Access Compliance Report

Public Rights-of-Way

Intersection ID: 42804	Main Street: AUDREY_LAKE_DR	Cross Street: SAWMILL_TRACE_DR	Location: NW
ADA ID: EA786105AE62	Ramp Type: PerpDiag	Initial Pass/Fail: Fail	Overall Compliance: No
		Severity Score: 25

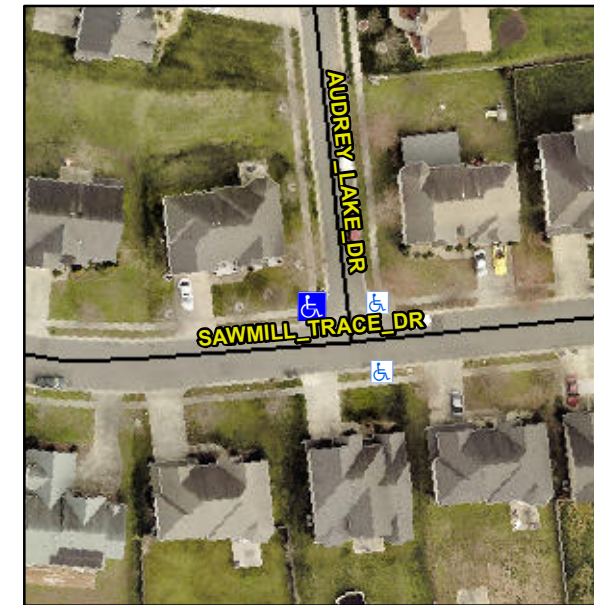
Not Found, R304.5.3

Compliance	Description	Data	Compliance	Description	Data
N/A	Ramp Length (in)	52.0	Yes	Ramp Slope (%)	6.6
Yes	Ramp Width (in)	48.0	No	Ramp XSlope (%)	7.0
N/A	Flare Type LT	N/A	N/A	Flare Type RT	N/A
N/A	Flare Slope LT (%)	N/A	N/A	Flare Slope RT (%)	N/A
N/A	Flare Traversable LT?	N/A	N/A	Flare Traversable RT?	N/A
N/A	Landing Length (in)	N/A	N/A	DWS Provided?	N/A
N/A	Landing Width (in)	N/A	N/A	DWS Contrast?	N/A
N/A	Landing Slope (%)	N/A	N/A	DWS Length (in)	N/A
N/A	Landing X Slope (%)	N/A	N/A	DWS Full Width?	N/A
N/A	Landing Curb? (Y/N)	N/A	N/A	DWS Offset (in)	N/A
N/A	Shared Landing?	N/A			
N/A	Gutter Ponding?	N/A	N/A	Gutter Slope (%)	N/A
N/A	Gutter Lip Ht (in)	N/A	N/A	Gutter X Slope (%)	N/A
N/A	Painted X Walk1?	No	N/A	Painted X Walk2?	No
	X Walk 1 Direction	To S		X Walk 2 Direction	To E
N/A	X Walk 1 Width (in)	N/A	N/A	X Walk 2 Width (in)	N/A
	X Walk 1 Slope (%)	1.7		X Walk 2 Slope (%)	0.5
	X Walk 1 X Slope (%)	0.9		X Walk 2 X Slope (%)	5.0

Remove & Replace Curb Ramp With Two New Directional Ramps or Equivalent.
